LAND NORTH-EAST OF JUNCTION 10 M42, DORDON

**Response to Review of Additional Information prepared
by LUC on
behalf of North Warwickshire Borough Council
Prepared for: Hodgetts Estates**

SLR Ref: 403.11077.00001
Version No: 3
May 2023

Figure 1: Snapshot of England's Light Pollution and Dark Skies (CPRE)

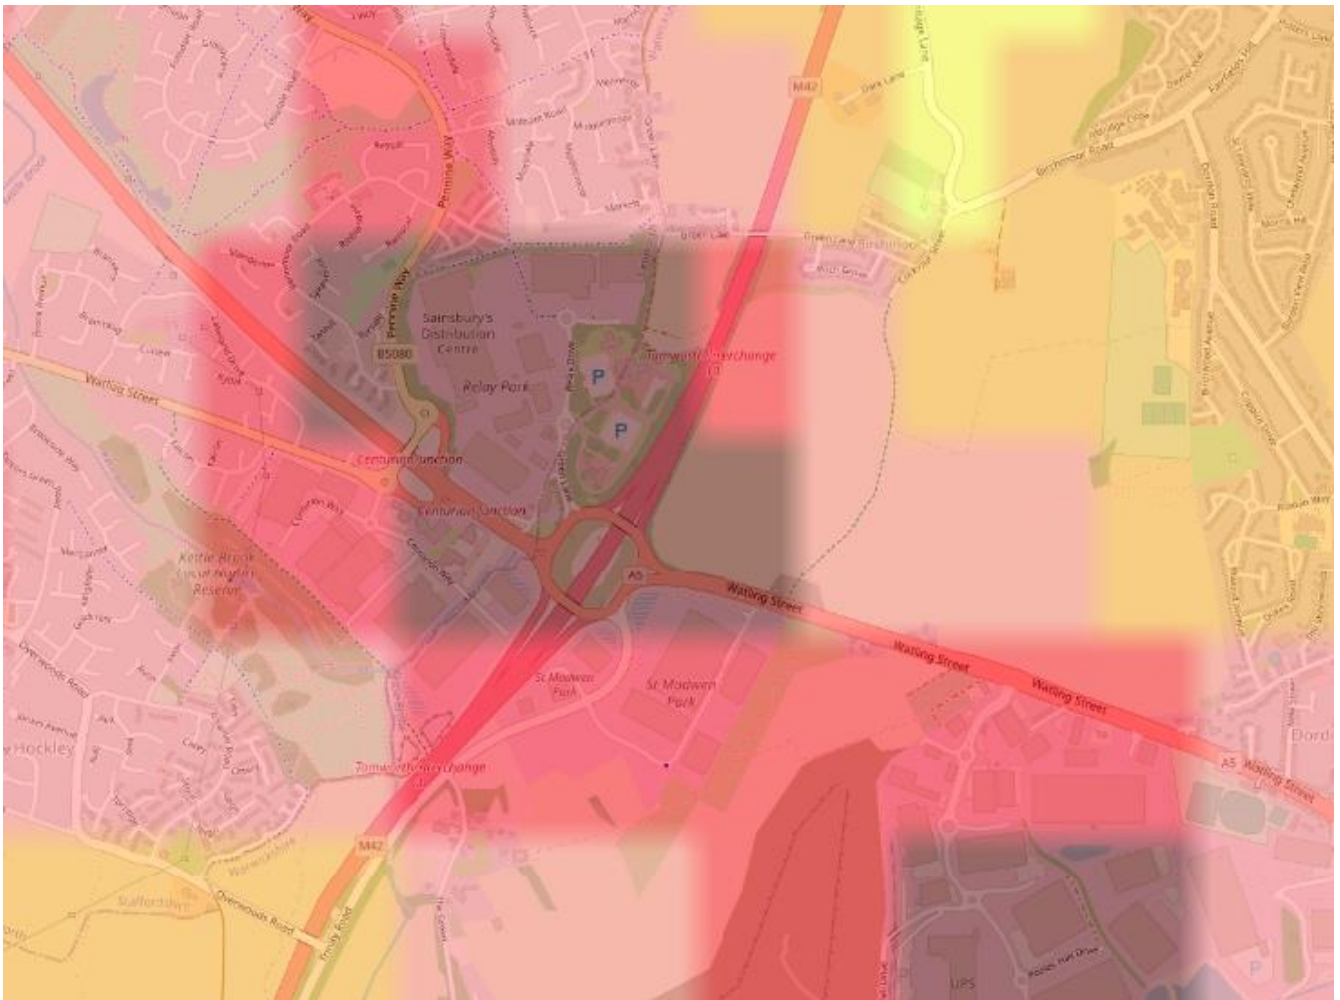
Concerns were raised about the affect of potential lighting and the potential for light levels within the local area to be increased.

A review of the interactive *“England’s Light Pollution and Dark Skies”* map provided by the CPRE was undertaken as part of the LVIA (Paragraph 10.4.18 or the ES, Chapter 10 and see Figure 1 below) to understand baseline lighting levels within and around the site.

These maps indicate that the baseline level of light across the site varies between >32 NanoWatts/cm²/sr (the brightest level of lighting) in the south-western part of the site reducing to 8-16 NanoWatts/cm²/sr (3rd brightest band) at the north-eastern part of the site. This indicates that the site is already strongly influenced by light from adjacent settlements and infrastructure. Lighting is already, therefore, a characteristic of the site and a sensitively designed lighting scheme with suitable controls would ensure that potential impacts would be limited.
